Product Change Notification

Product Change Notification: E-17-016522

Universal Mate-N-Lok Housings

007790-350777

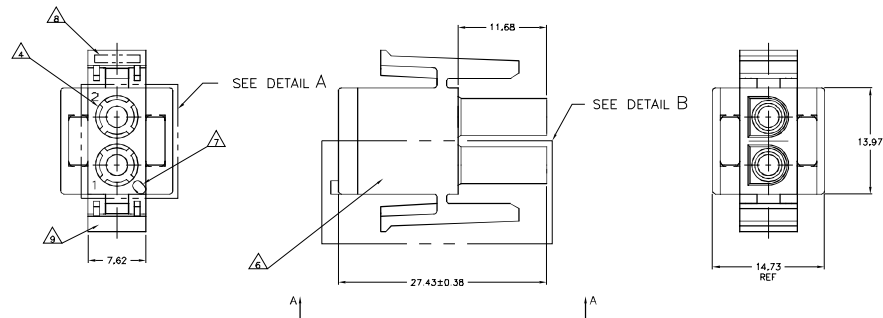
- △ TRADEMARK LOCATION (AMP OR TE CONNECTIVITY) SHOWN FOR CONVENIENCE. LOGO MAY BE ON ANY EXTERNAL SURFACE.
 - △ MANUFACTURING LOCATION ID (OPTIONAL).
 - △ MATERIAL: UL94 V-0, GWT 775°C

△ NATURAL	2-350777-1
BLACK	1-350777-9
GRAY	1-350777-8
BLUE	1-350777-6
GREEN	1-350777-5
YELLOW	1-350777-4
ORANGE	1-350777-3
RED	1-350777-2
BROWN	1-350777-1
△	350777-4
NATURAL	350777-1
COLOR	PART NUMBER

REVISIONS				
#	DATE	DESCRIPTION	BY	APP
P7	09NOV2017	REVISED PER ECR-17-016522	SC	BH

CAP, SINGLE CIRCUIT, UNIVERSAL MATE-N-LOK™

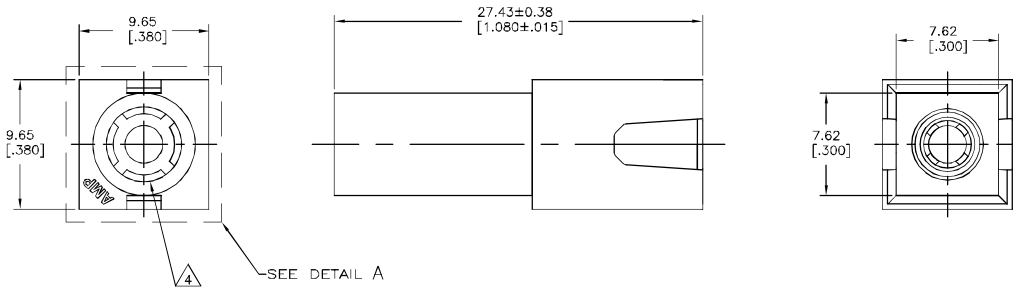
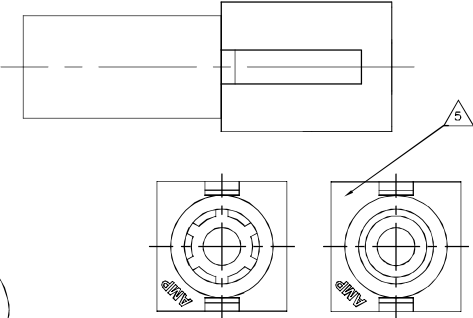
- △4 FOUR RIBS EQUALLY SPACED, NO SPECIFIC ORIENTATION. NO RIBS OR SIX RIBS EQUALLY SPACED, NO SPECIFIC ORIENTATION, OPTIONAL.
- △5 CSA LOGO LOCATED APPROXIMATELY AS SHOWN
- △6 MATERIAL: GWIT 775°C

△	NATURAL	1-350866-1
	RED	350866-2
	NATURAL	350866-1
	COLOR	PART NO.

00779 480699

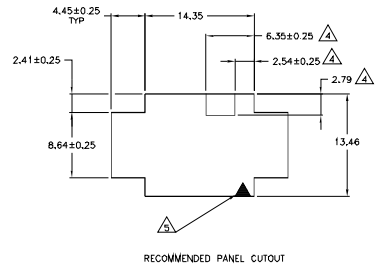
- ⚠ PREPRODUCTION - FASR REQUIRED.
 - ⚠ MATERIAL: UL94 V-0, GWT 775°C

⚠ NATURAL	3-480699-0
⚠ NATURAL	2-480699-0
BLACK	1-480699-3
GREY	1-480699-8
BLUE	1-480699-6
GREEN	1-480699-5
YELLOW	1-480699-4
ORANGE	1-480699-3
RED	1-480699-2
BROWN	1-480699-1
NATURAL	1-480699-0
COLOR	PART NO.

REVISIONS				
#	DATE	DESCRIPTION	BY	APP
R4		REVISED PER ECR-17-016522	09NOV2017	SC BH

PLUG,
SINGLE CIRCUIT,
UNIVERSAL MATE-N-LOK™

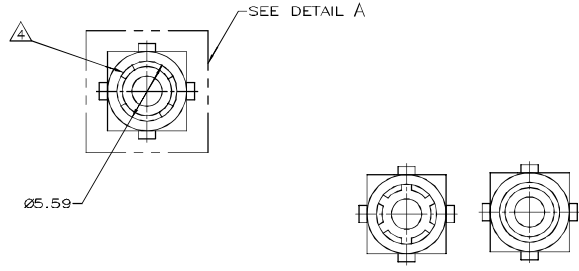
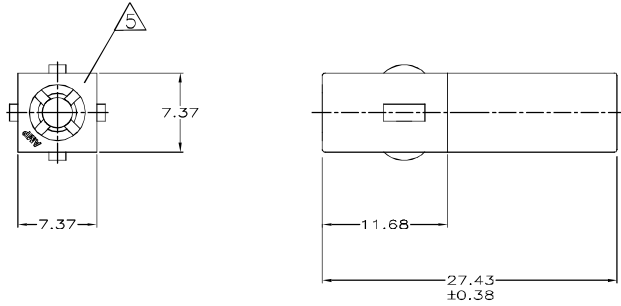
6 MATERIAL: GWIT 775°C

6	NATURAL	1-350865-1
	NATURAL	350865-1
	COLOR	PART NO
